AMENDMENT OF SOLICITATION / MODIFICATION OF CONTRACT

1. AMENDMENT/MODIFICATION AM 05	2. EFFECTIVE DATE
3. ISSUED BY PURCHASING SECTION Office of Procurement and Materials	4. ADMINISTERED BY (If other than block 3) Benjamin T. Kpadeh
5. CONTRACTOR NAME AND ADDRESS <small>(Street, city, county, state, and Zip Code)</small>	6. FORM TYPE (Check only one) <input checked="" type="checkbox"/> AMENDMENT OF SOLICITATION NO. FQ15188 DATE <u>June 24, 2015</u> (See block 7) <input type="checkbox"/> MODIFICATION OF CONTRACT/ORDER NO. _____

QUESTIONS AND ANSWERS
OF
IFB No. FQ15188 – Power Distribution Unit for the Data Center

JACKSON GRAHAM BUILDING
 ADDITIONAL PDUS TO DATA CENTER
 SINGLE LINE DIAGRAM-EXISTING WITH NEW PDUS

DRAWING NO. E-102b SHEET NO. 1 OF 1

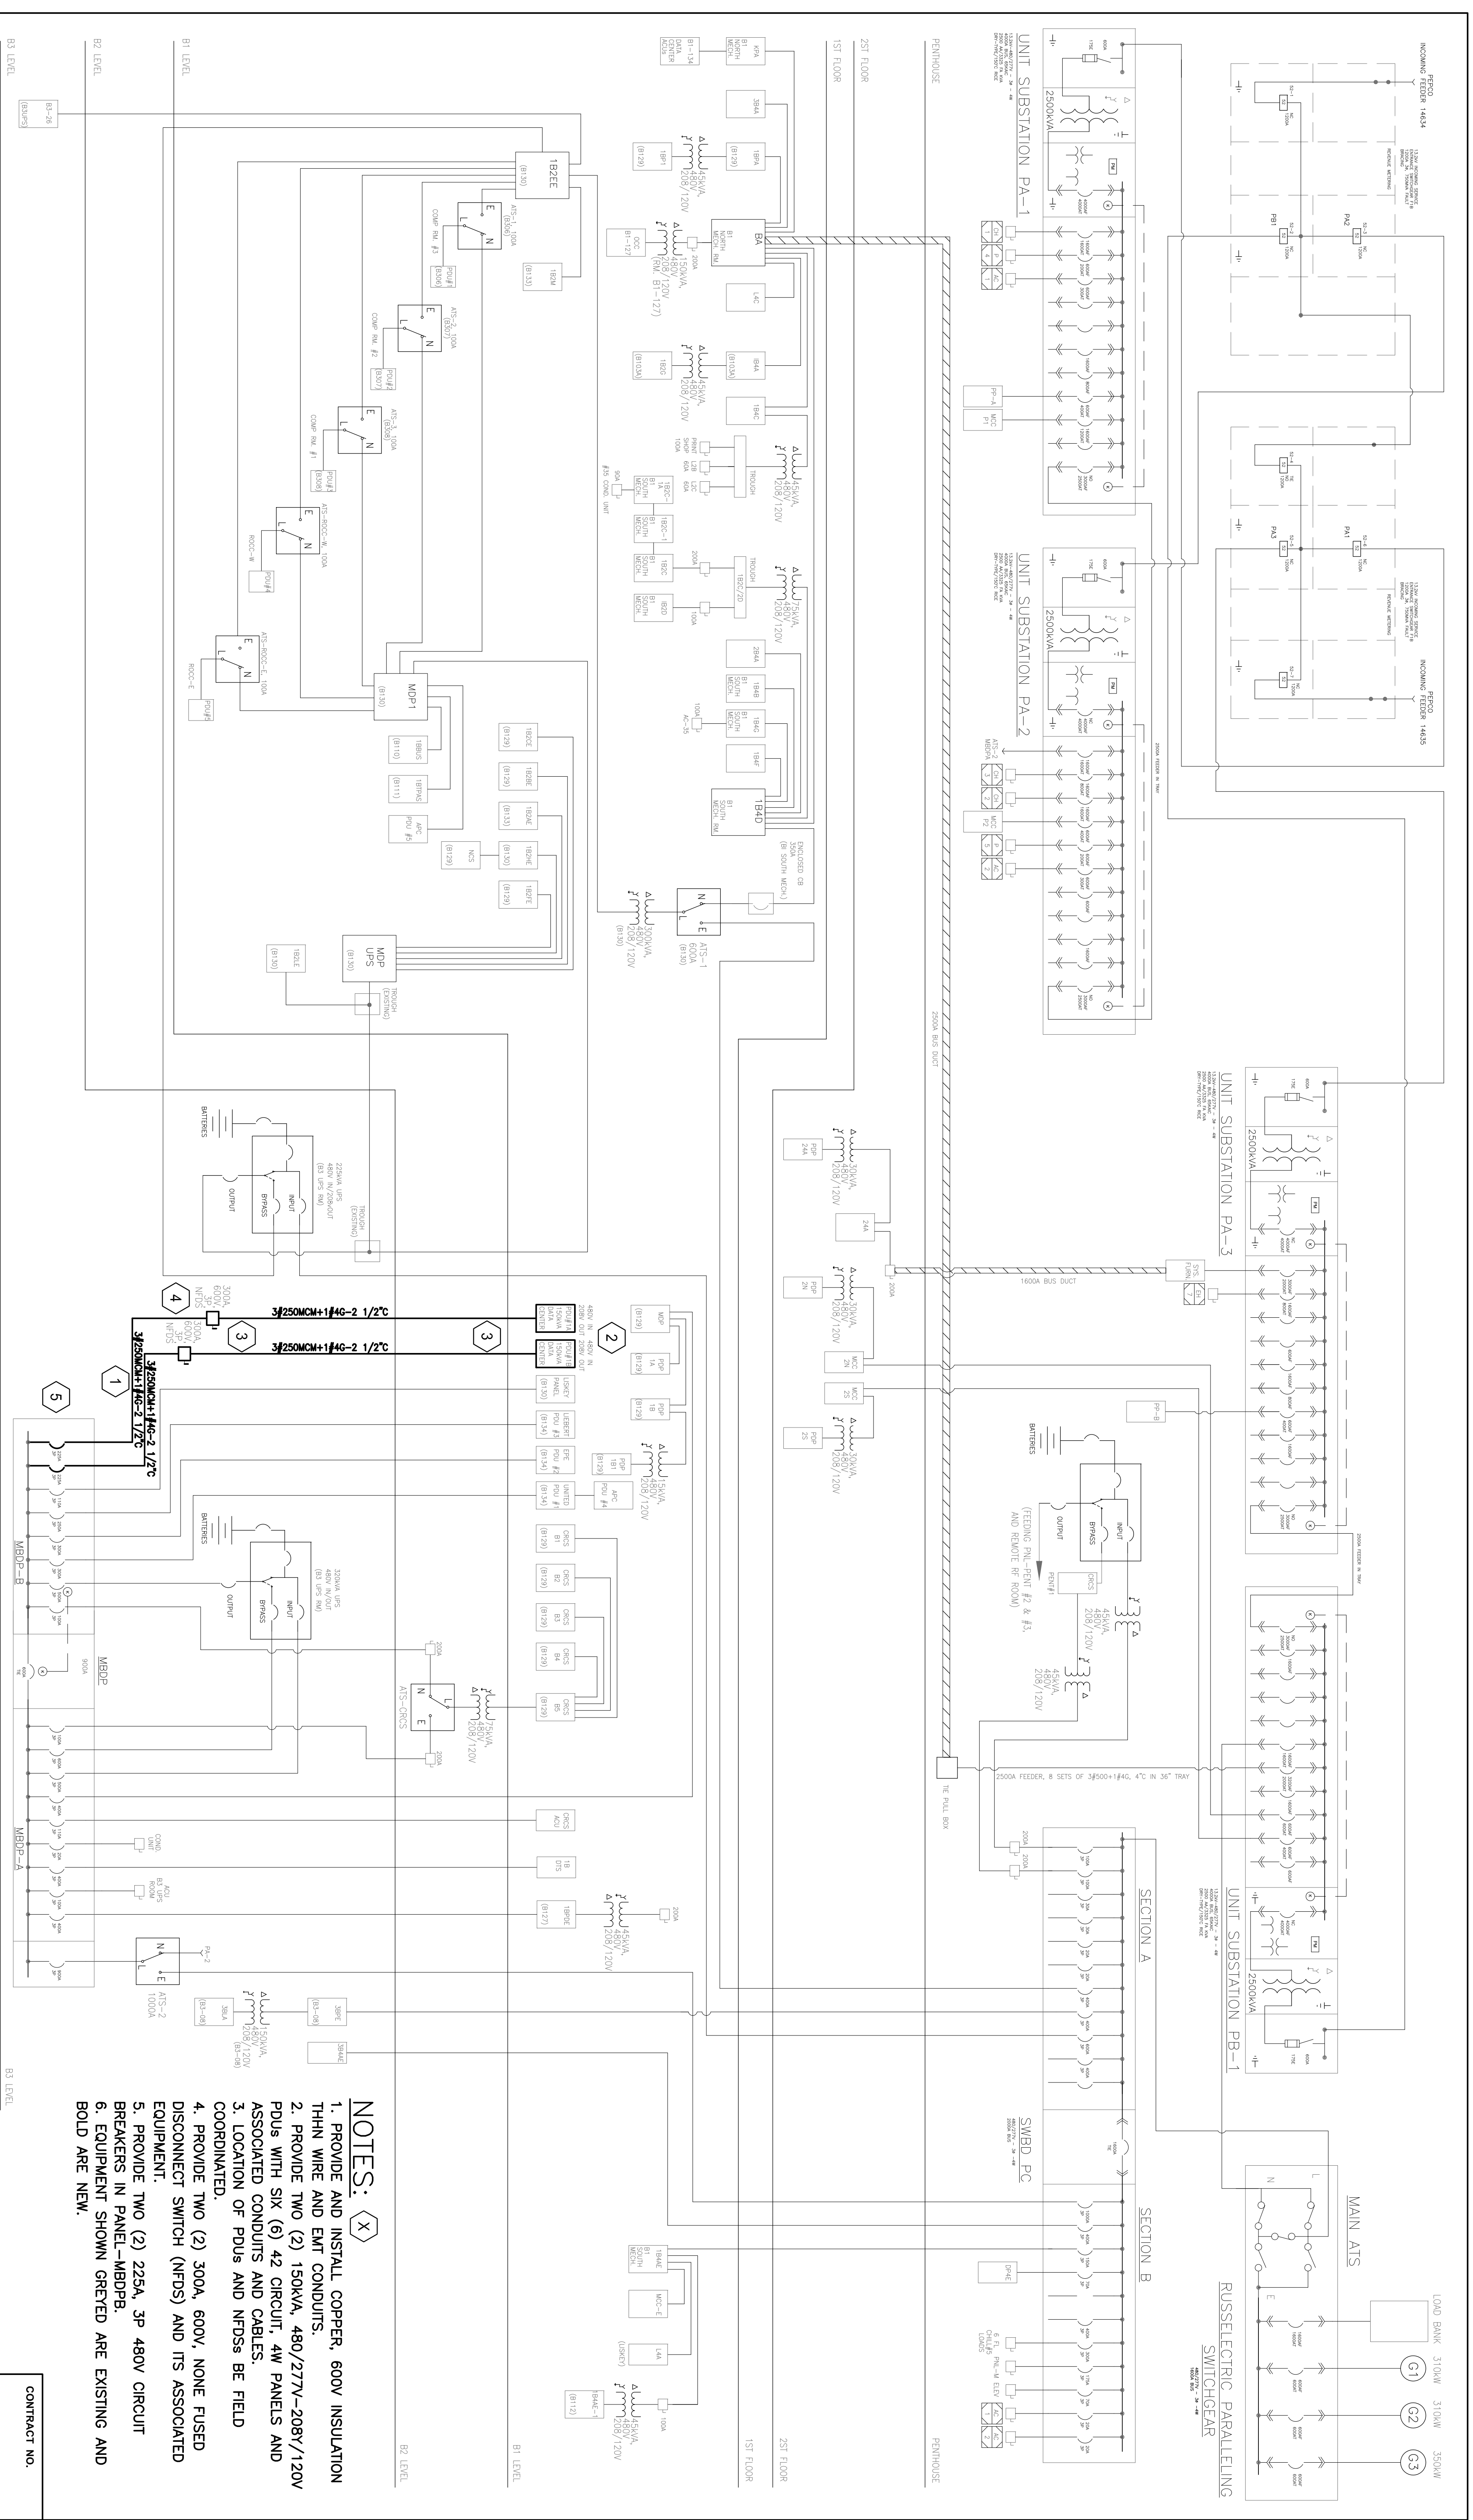
Line #	Prospective Offerors' Question	WMATA Answer
1	It appears the Single Line diagram (E-102a) is bolded to provide additional equipment not identified in the RFP. For example, the 300A step down transformer and the 500Kva UPS. Please confirm WMATA only wants what equipment is identified on the price list. Does labor stop at providing .	<i>Provide only item identified in the RFP and the revised scope of work and drawing. See attached revised drawing.</i>
2	Pricing Schedule does not identify the provision of installation of the 500kVA UPS Cabinet with (13) 25kw power modules on the B1 Level. However, Note 2 of drawing provided 06/19 indicates there is a 500kva UPS cabinet to be provided. Please clarify if this is intended and if so, where it is to be placed and where the provision to price this is on the Price Schedule.	<i>Please provide what is required in the IFB including the revision that have be made, see attached documents.</i>

3	Drawing E-102a is bolded to indicate per Note 3 there are new batteries to be provided and configure. Please confirm if this is correct and identify on the price schedule where this is to be priced for equipment and labor.	<i>Please provide what is required in the IFB including the revision that have be made, see attached documents.</i>
4	During the site visit walk through of 6/19, the existing trough for the new feeds (per note 7 of drawing E-102a) was not identified. Please provide more information on this.	<i>Please provide what is required in the IFB including the revision that have be made, see attached documents.</i>
5	Please identify if there are existing conduits that can be utilized to run from the MBDP panels per Note 4 on drawing E-102a, or if new conduits and wiring (plus labor) must be priced. Can you confirm there are existing conduit and wires the Contractor can use? If not, where on the price schedule should the additional labor and material be accounted for?	<i>Provide price for new conduit and wiring. See attached revised drawing.</i>

6	Note 6 of Drawing E-102a indicates a 200A, 3phase 4wire MCB panel with (2) 100A 3phase circuit breakers are to be provided. This comes off a 150kva, 3phase step down transformer feed from a 300A disconnect switch. Does the Contractor provide this? If so, where	<i>Please provide what is required in the IFB including the revision that have be made, see attached revised documents.</i>

is the provision for the equipment and labor on the price schedule?	
7	Drawing E-102a shows additional wiring from a MCB panel (Note 6). Please confirm this is required and if so, where this is accounted for on the price schedule for equipment and labor.	<i>Please provide what is required in the IFB including the revision that have be made, see attached revised documents.</i>
8	Will WMATA be issuing out an amended Statement of Work to accompany the details brought out in today's walk through?	<i>See attached revised scope of work that is attached to this amendment.</i>
9	Please provide an electronic file of the One Line Drawing that was presented to us at the site visit today.	<i>We can only provide pdf file. See attached revised drawing.</i>
10	Please provide an electronic file of the Building Floor Drawing so we can determine distance from the Electrical room in the basement to the Data Center.	<i>Drawing will be provided to the contractor that will be awarded the contract.</i>

38	Will there be an updated scope sent out for the PDU RFP? Also, I would like to request a cleaner copy of the one line drawing that was sent. The one that was sent wasn't very good quality and no matter how much you blow it up it is largely illegible with none of the specifics needed being clear enough to read.	<i>Please refer to revised scope of work (SOW) that is attached.</i>
39	Recently my firm received an RFQ to bid on a pair of PDUs for one of your facilities. From all of the information I gathered from the documents we received, the only named approved manufacturer for this hardware was MGE. I did not see a sole source provision anywhere, which is why I'm requesting that my company be approved as an alternate bidder. We represent Eaton Powerware UPS, PDUs, and Switchgear in the Washington, DC metro area. 3a. I've attached some comparison information regarding Eaton PDUs vs. MGE. I can provide whatever technical information you require as well. Please let me know the process of getting Eaton approved as an alternative bidder.	<i>This project consist of several phases. In order to maintain consistency and for integration purpose it is critical to provide equipment as specified.</i>

- NOTES:** (X)
1. PROVIDE AND INSTALL COPPER, 600V INSULATION THIN WIRE AND EMT CONDUITS.
 2. PROVIDE TWO (2) 150KVA, 480/277V-208Y/120V PDUS WITH SIX (6) 42 CIRCUIT, 4W PANELS AND ASSOCIATED CONDUITS AND CABLES.
 3. LOCATION OF PDUS AND NFDSS BE FIELD COORDINATED.
 4. PROVIDE TWO (2) 300A, 600V, NONE FUSED DISCONNECT SWITCH (NFDs) AND ITS ASSOCIATED EQUIPMENT.
 5. PROVIDE TWO (2) 225A, 3P 480V CIRCUIT BREAKERS IN PANEL-MBDPB.
 6. EQUIPMENT SHOWN GREYED ARE EXISTING AND BOLD ARE NEW.
